## **CAMDEN POINTE SUBDIVISION**

APPLICATION NUMBER 21 DATE June 21, 2007

REQUEST Subdivision

# DETAIL SITE PLAN

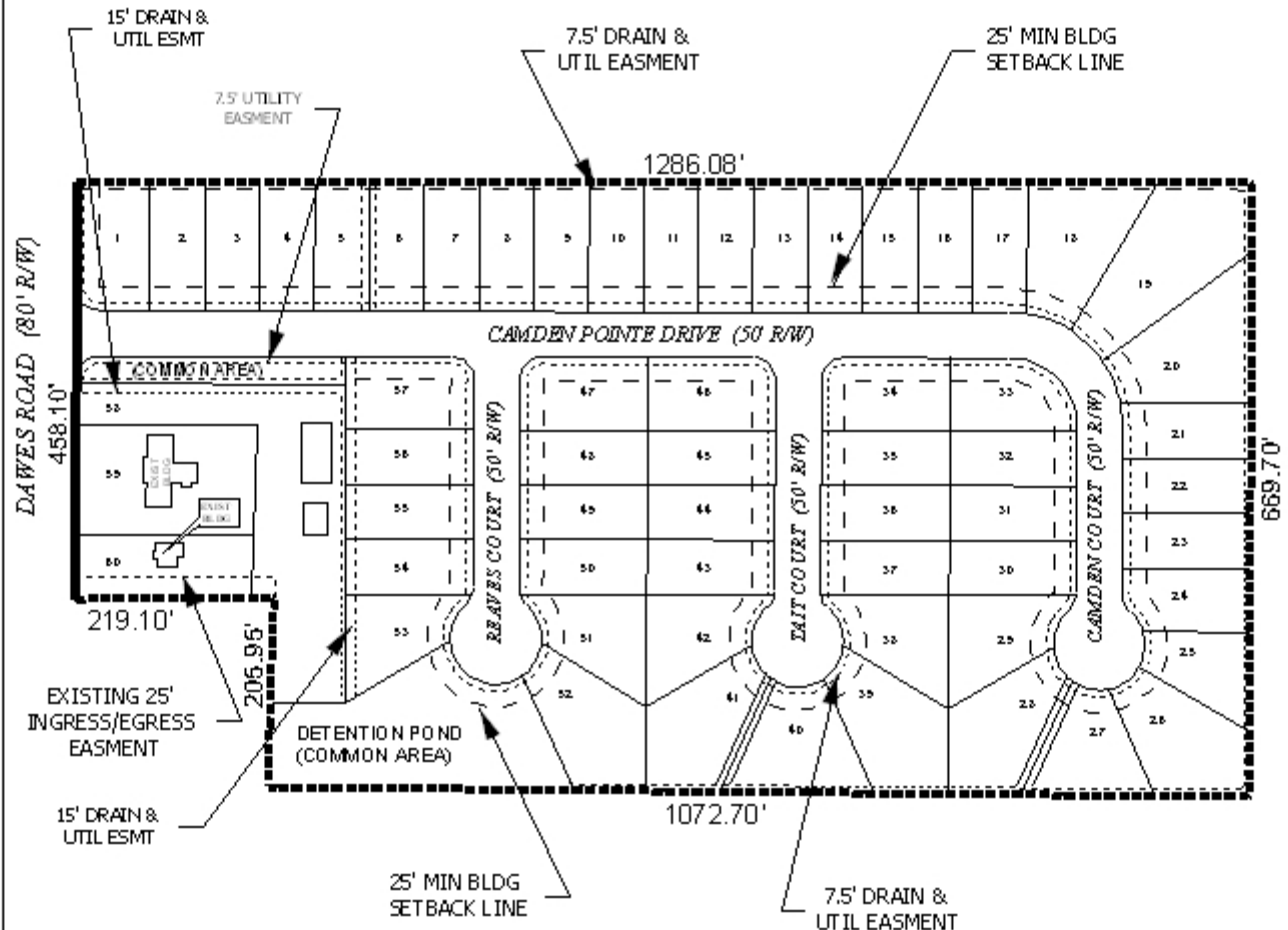
The site fronts Dawes Road, a proposed major street with a right-of-way of 80-feet. As a proposed major street, the right-of-way should be a minimum of 100-feet, thus sufficient right-of-way should be dedicated to Mobile County to provide 50 feet, as measured from the centerline of Dawes Road.

Access management is a concern due to Dawes Road's status as a proposed major street. Proposed Lot 1 will have frontage on both Dawes Road and Camden Pointe Drive, a street proposed as part of the subdivision: Lot 1 should be denied direct access to Dawes Road. Proposed Lots 58-60 will only have frontage on Dawes Road, therefore each lot should be limited to one curb-cut each. All lots, except as previously stated, should be limited to one curb-cut each, with the size, design and location to be approved by Mobile County Engineering.

The 25-foot minimum building setback line should be depicted for all lots, even those with existing development. The setback line for those lots with frontage on Dawes Road should also be depicted, and should reflect the required dedication. The setback line should be depicted where the lots are a minimum of 60-feet in width.

Lot 58 will be a flag lot with approximately 46 feet of frontage onto Dawes Road. It appears that the lot will accommodate existing development. The odd shape of the lot will require a waiver of Sections V.D.1. and V.D.3. of the Subdivision Regulations, and it is recommended that no future subdivision of the lot be allowed until additional frontage on a public street is provided.

Common areas and detention areas are shown on the plat. A note should be placed on the plat stating that maintenance of the common areas and detention common areas shall be the responsibility of the property owners.

A note should be placed on the Final Plat stating that any lots which are developed commercially and adjoin residentially developed property must provide a buffer, in compliance with Section V.A.7. of the Subdivision Regulations.

With a waiver of Sections V.D.1. and V.D.3. for Lot 58, the plat is recommended for Tentative Approval, subject to the following conditions:

- 1) provision of documentation to the Planning Section of Urban Development verifying that parcel R023406140000004.001. has had multiple ownership changes, prior to the signing of the final plat;

- 2) dedication of right-of-way sufficient to provide 50-feet, as measured from the centerline of Dawes Road;
- 3) depiction of the 25-foot minimum building setback line for all lots (including lots 58-60), adjusted to reflect required dedication;

- 4) placement of a note on the final plat stating that Lot 1 is denied direct access to Dawes Road, and that all lots are limited to one curb-cut each, with the size, design and location of all curb-cuts to be approved by the Mobile County Engineering Department;

- 5) placement of a note on the plat stating that future subdivision of Lot 58 not allowed until additional frontage on a public street is provided;
- 6) provision of a certification letter from a licensed engineer to the Planning Section of Urban Development, certifying that the stormwater detention, drainage facilities, and release rate comply with the City of Mobile stormwater and flood control ordinances, prior to the signing and recording of the final plat;

- 7) revision of the plat to label each lot with its size in square feet, or provision of a table on the plat depicting the same information;
- 8) labeling of all common areas, including the detention basins, and placement of a note on the final plat stating that maintenance of the common areas is the responsibility of the subdivision's property owners; and

- 9) placement of a note on the Final Plat stating that any lots which are developed commercially and adjoin residentially developed property must provide a buffer, in compliance with Section V.A.7. of the Subdivision Regulations.
